Independent Assessment of Basement Excavation Justification for Planning Application 2012/4744/P

Client:	London Borough of Camden
Site:	12 Elsworthy Road London NW3 3DJ
CCS Ref:	BIA/3685
Dated:	April 2013

Figure 1: Section 4-4 from HRW drawing 1031/PL/06 rev.P1 showing foundation to No.14's flank wall (level assumed = to No.12's) and 45 degree influence line from proposed basement excavation.

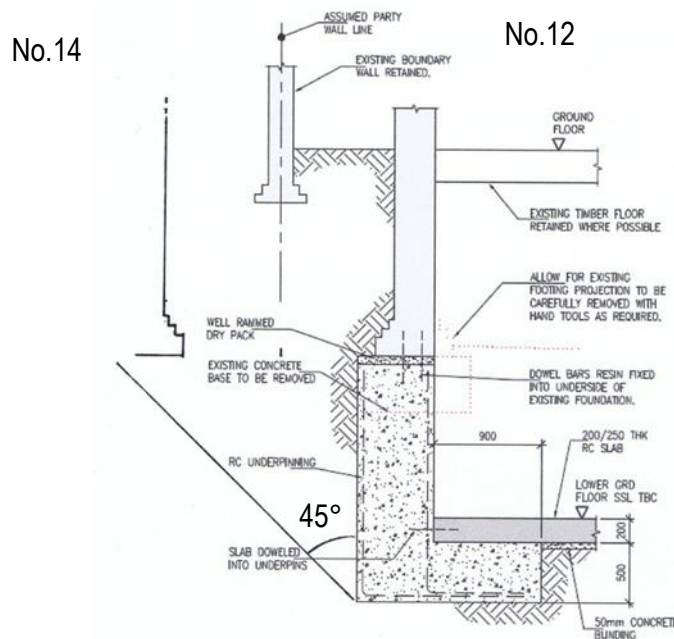
- 2.3.6 The flank wall to No.14, where not party, is shown on the ground floor plan (Drg 1031/PL/03) but not on the basement plan (Drg 1031/PL/02) nor on Section 4-4 (Drg 1031/PL/06). Figure 1 shows Section 4-4 with the foundation to No.14's flank wall added at the same depth as No.12's footing; this illustrates that is well within/above a 45 degree line drawn from the bottom corner of the proposed underpinning base. The design of the proposed underpinning must therefore allow for supporting the imposed load from No.14's flank wall and for maintaining full support to the ground beneath and alongside those footings, both during the underpinning works and permanently thereafter.
